SITE PLAN REVIEW COMMITTEE MEETING AGENDA

A. Review and take action: Edge Field Preliminary Plat

B. Review and take action: Hunter Oaks Enclave Preliminary Plat

RE: Edge Field Preliminary CSM Review

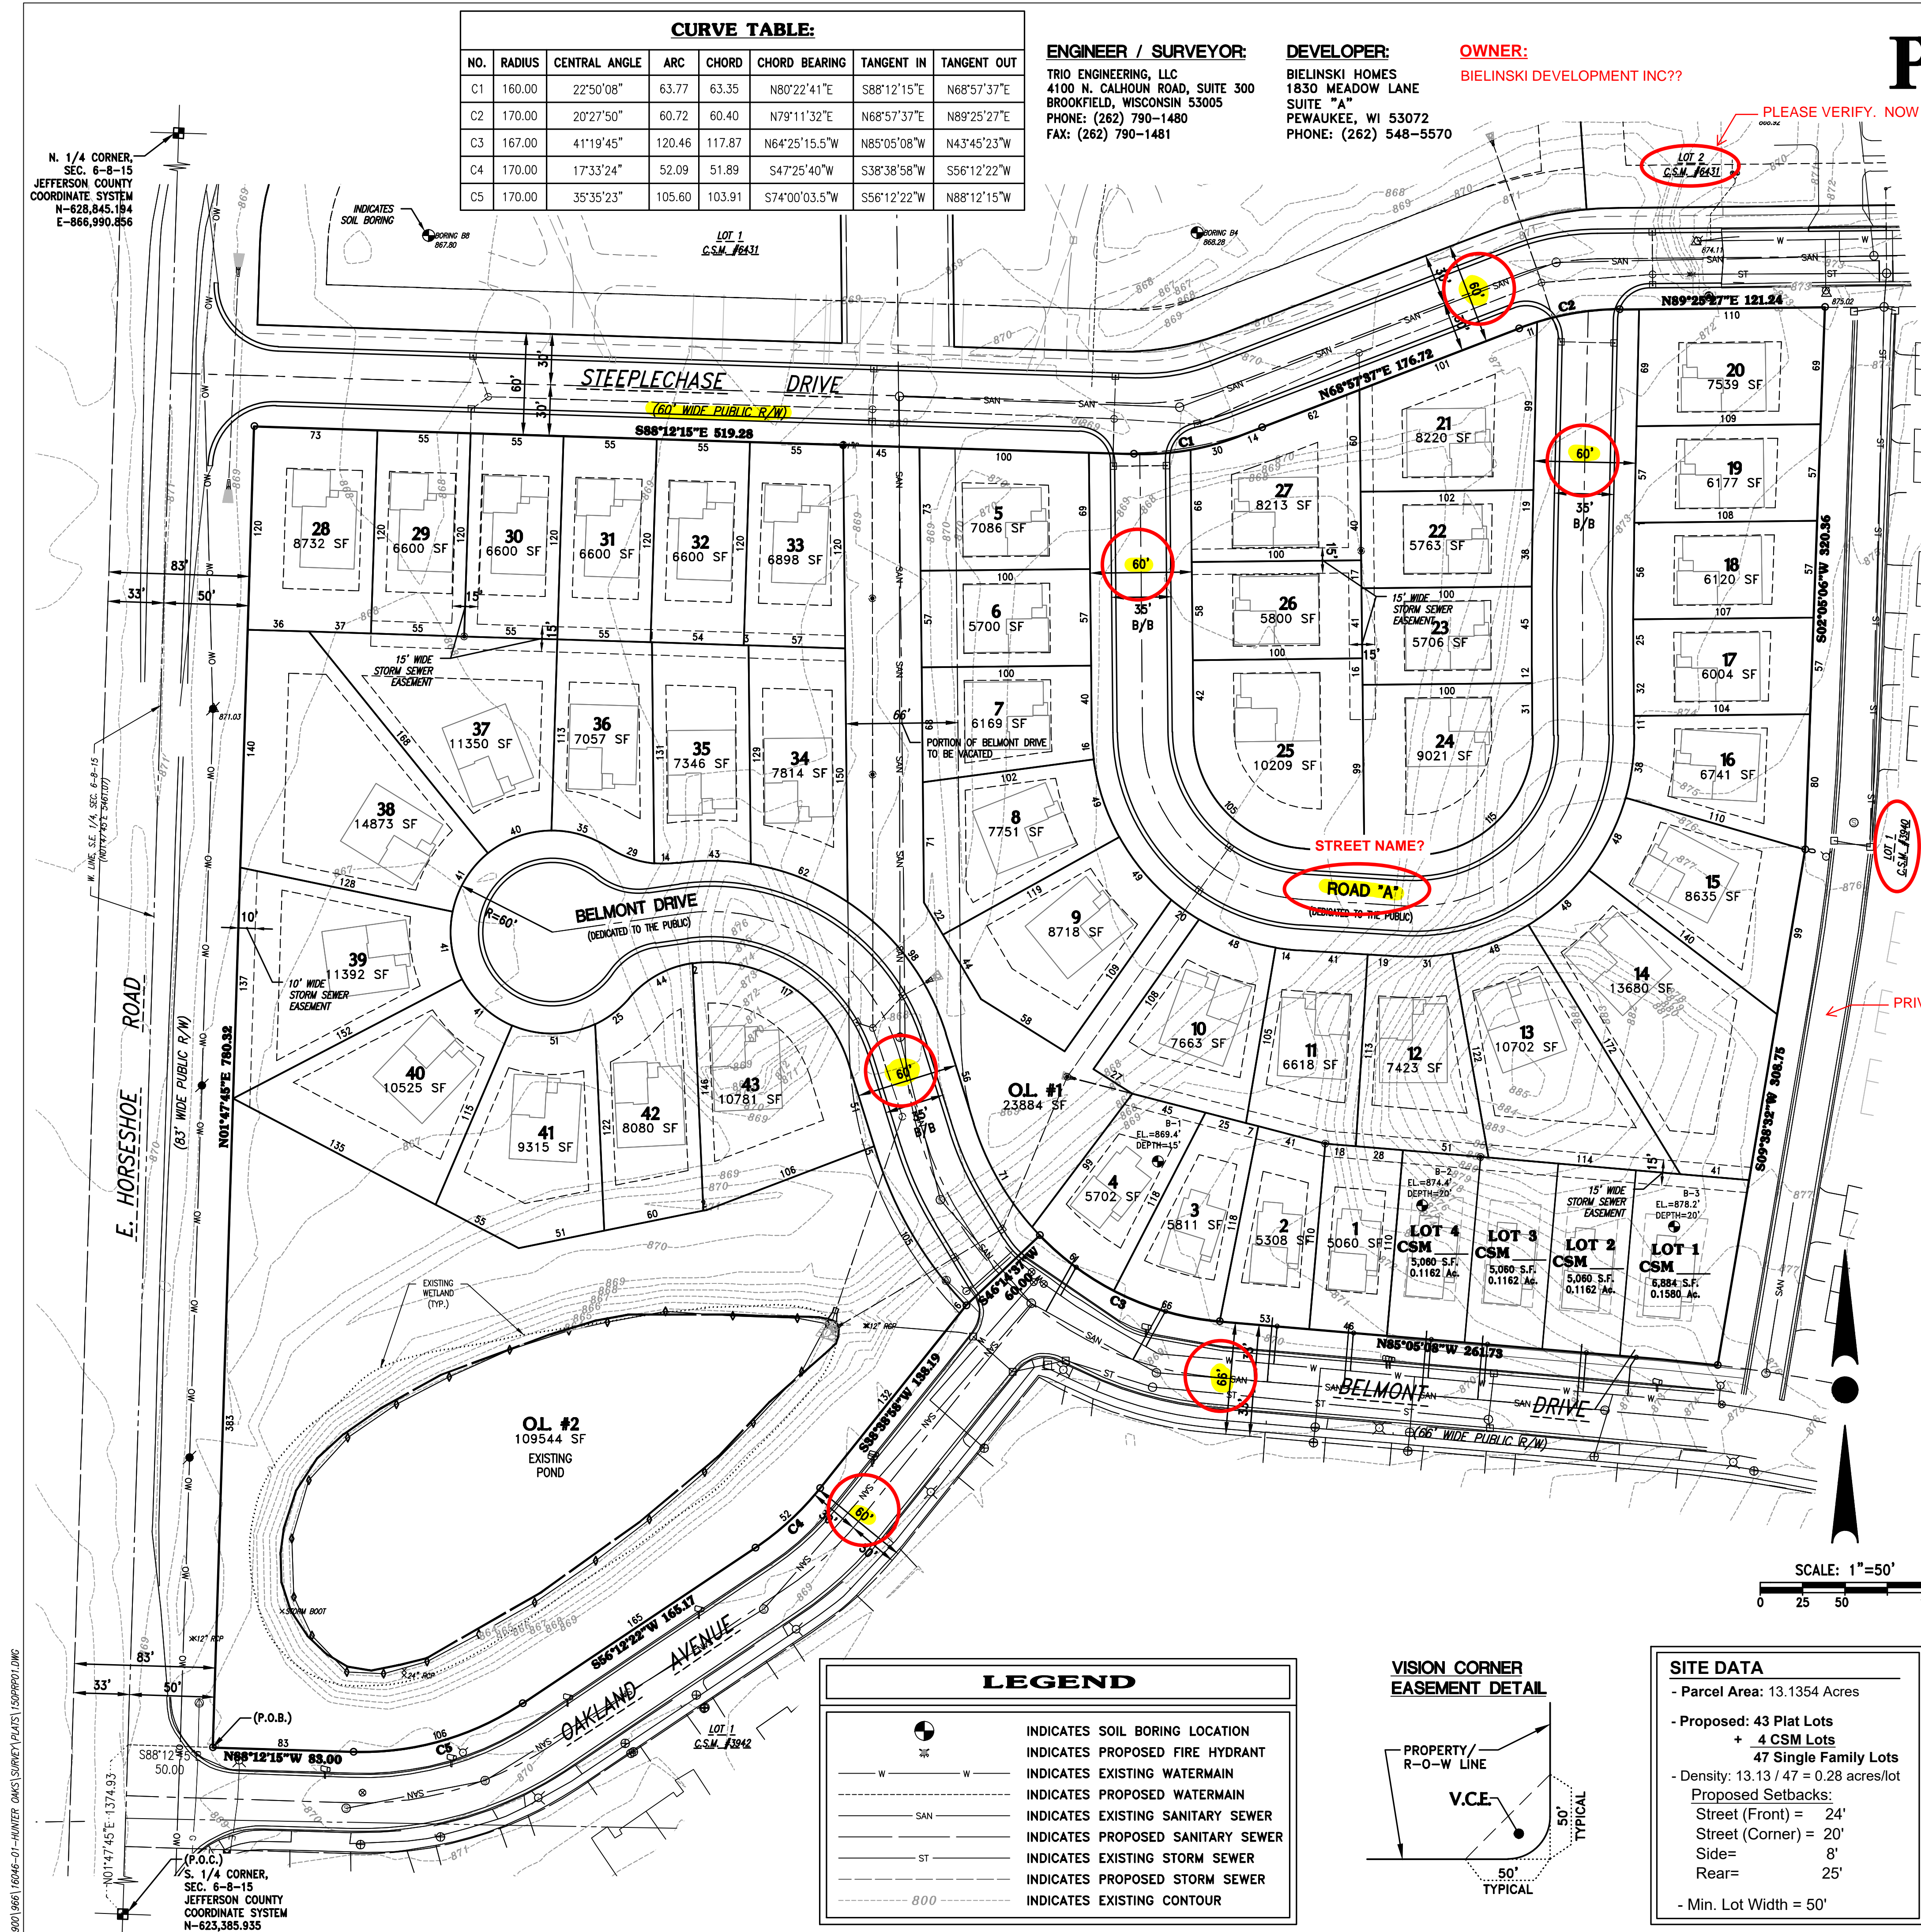
1. There appears to be a bust in the exterior boundary; it does not close by approximately 30+ feet.
2. 545-13B(3)(a), Proposed Road “A” should be given its proper name.
3. 545-13B(1)(b), Provide the name and address of the property owner on the plat.
4. 545-13B(2)(i), Verify the current platting status of lands lying east and northeast of plat. They are shown as CSM lots but county parcel mapping shows them as Condo plats.
5. 545-13B(2)(j), Show the existing land use and current zoning information.

1. 545-13B(3)(c), Provide a draft of proposed covenants, if any, to be imposed.
2. 545-13B(2)(d), label the existing alley adjacent to the preliminary plat.

3. 545-13B(3)(e), Provide a statement from a licensed engineer representing the project that certifies that the technical requirements of City Code § 545 will be met when final engineering design plans (including plans and profiles for public improvements and grading, erosion control, and stormwater management plans) are submitted. Such final engineering design plans shall be submitted and approved by the City Engineer prior to approval of the final plat.

4. 545-13B(2)(h), all final engineering approved plans shall provide the size and invert elevation of any existing sanitary and storm sewers, culverts, or drainpipes and the location and size of any existing water and gas mains on or adjacent to the plat and for proposed use in the development.

5. 545 Attachment 2, The City’s minimum right-of-way (ROW) width for Residential (typical) roads is 66 feet. The preliminary plat includes a ROW of 60 feet. Provide a typical cross-section or plan showing the proposed improvements meeting City standards (roadway, curb and gutter, terrace, sidewalk, etc.) will fit within the 60 foot ROW.

6. Show all required drainage easements per City code.

Please find enclosed the preliminary plat with markups for some of the above comments.
